**FINAL DRAINAGE REPORT
FOR
SADDLEHORN RANCH – FILING 5 EARLY GRADING**

**September 1, 2022
Project No. 25142.07**

El Paso County PCD File No.:
EGPXXX
EGP226

EXISTING CONDITIONS MAP
SADDLEHORN FILING 5
PROJ. NO. 25142.07
8/26/22
SHEET 1 OF 1

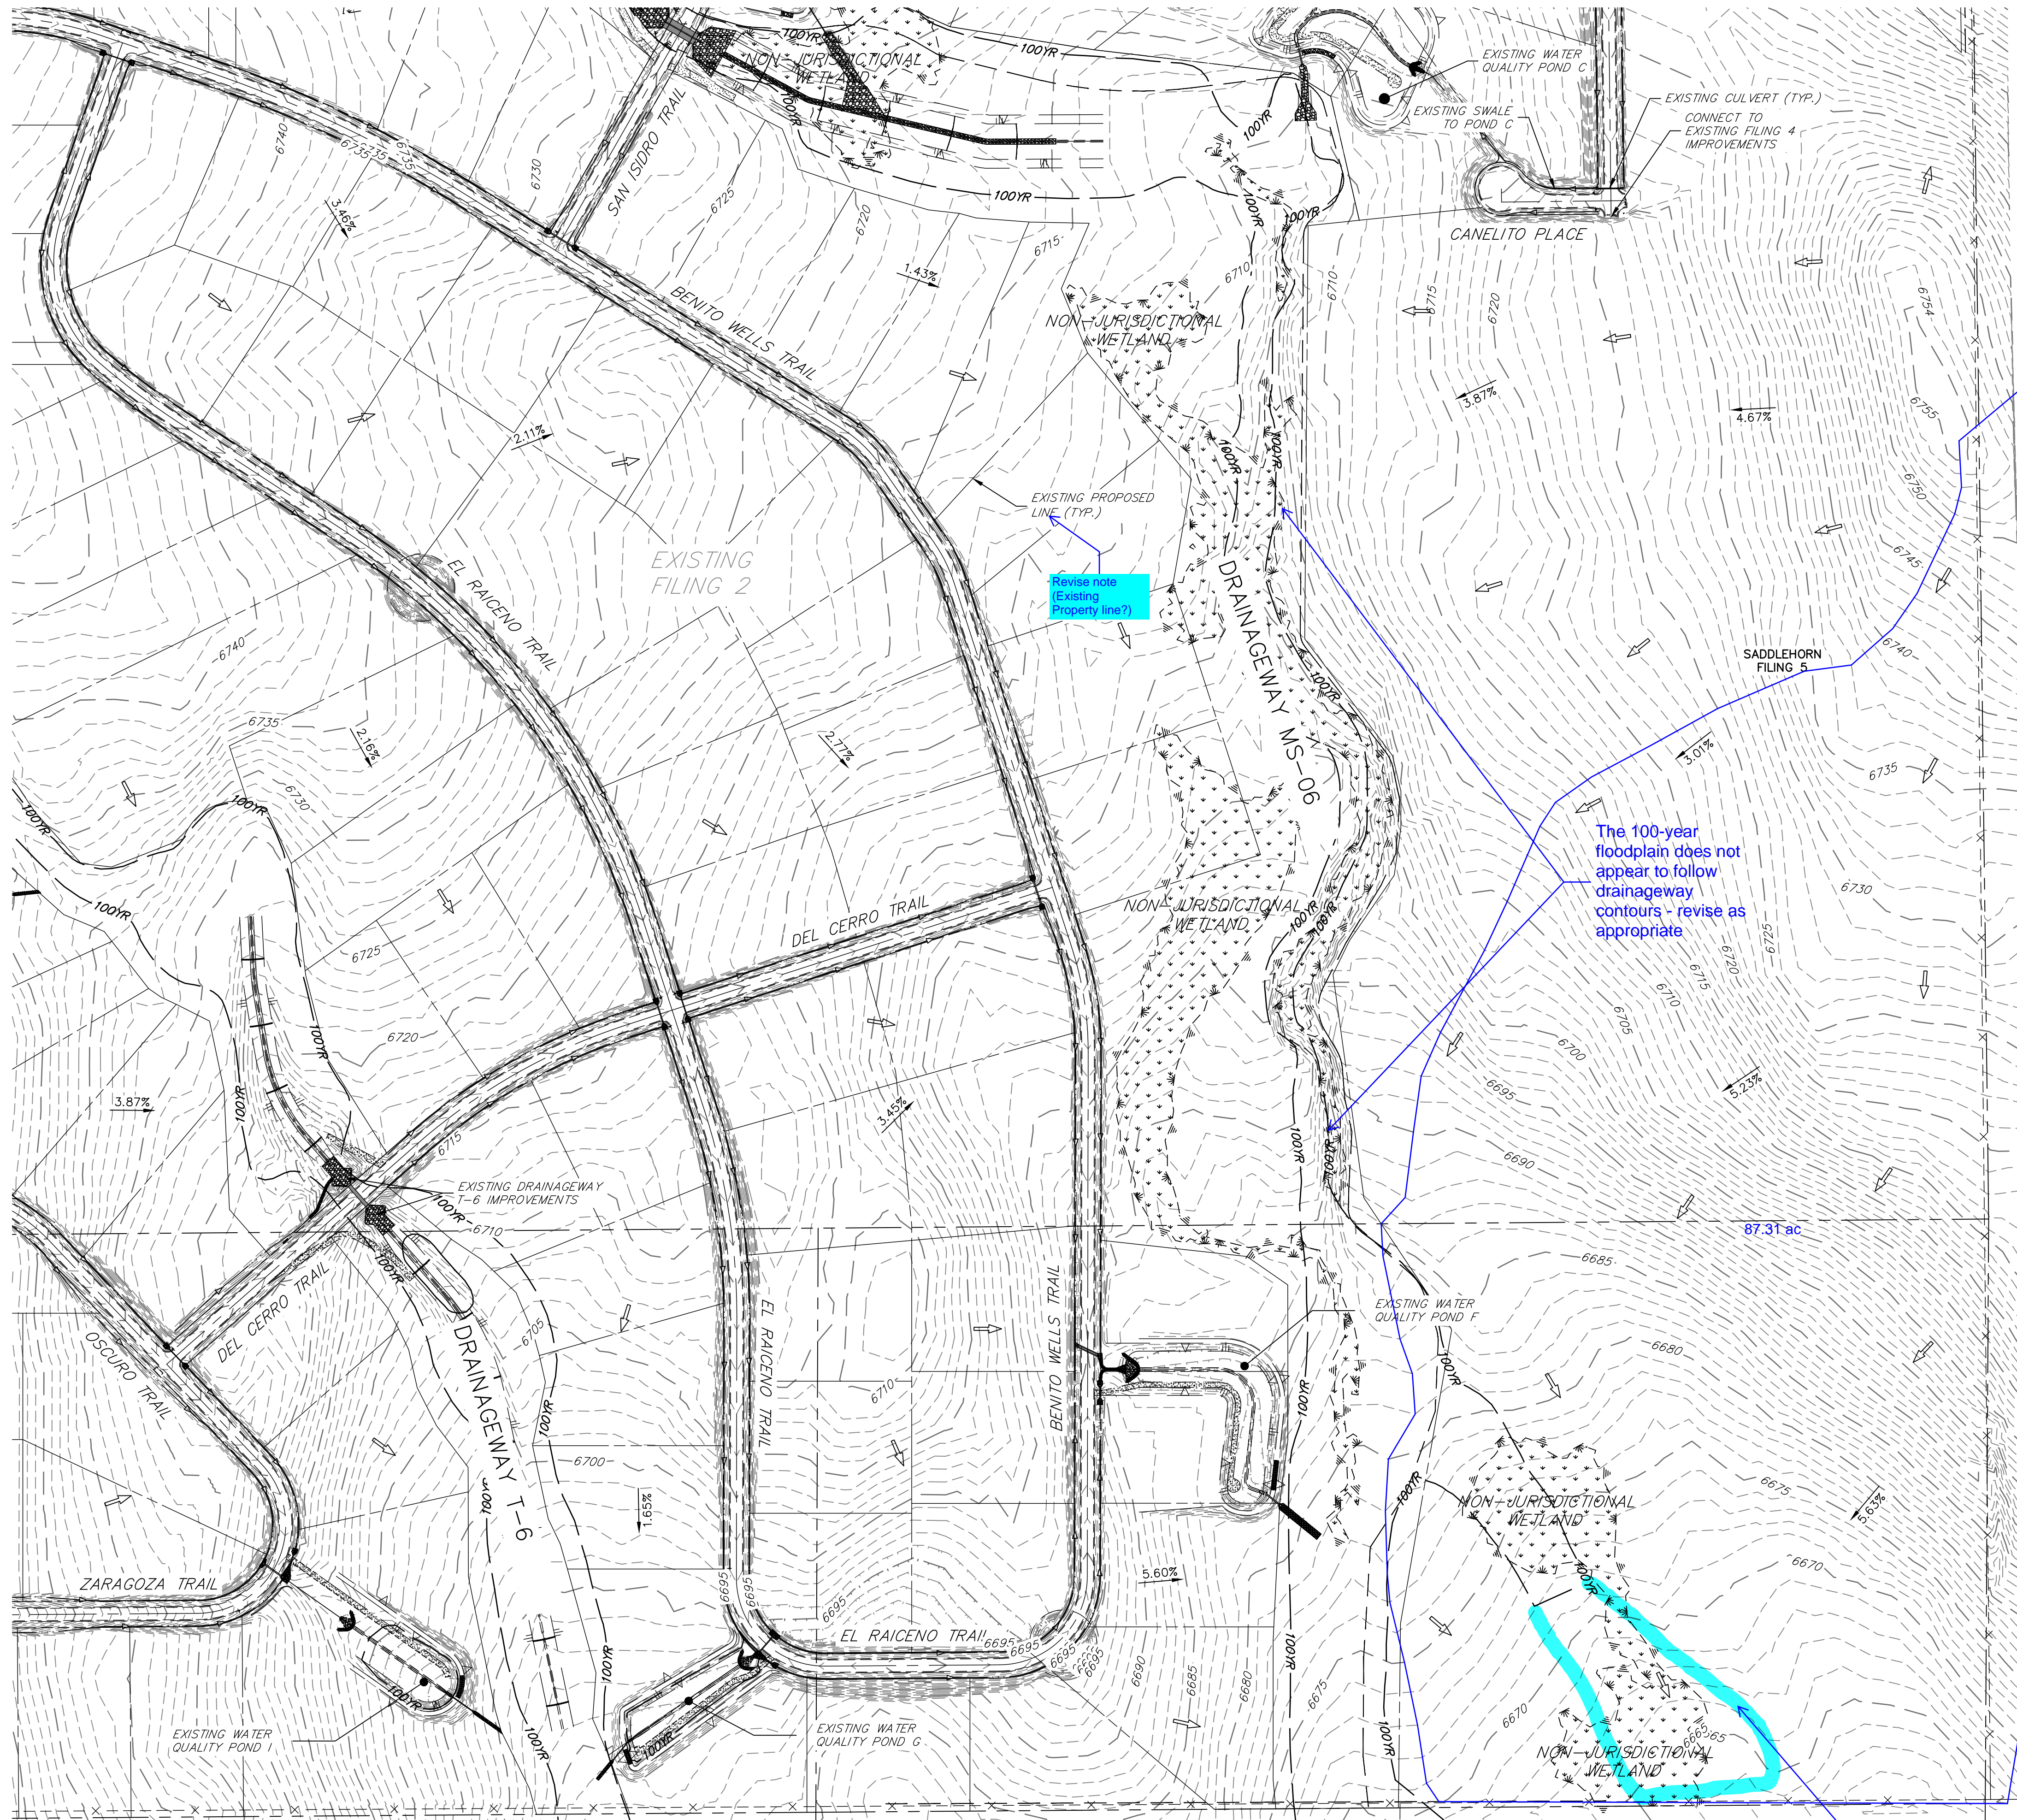
Address what portion of the basin currently flowing to the south will be diverted to the west through the proposed detention pond and what the impacts to the channel will be. This will be a larger issue with the final plat.

Provide sub-basins, design points, flows, etc. for comparison to developed condition design points

The 100-year floodplain does not appear to follow drainage contours - revise as appropriate

show the rest of the 100-year floodplain to the property line
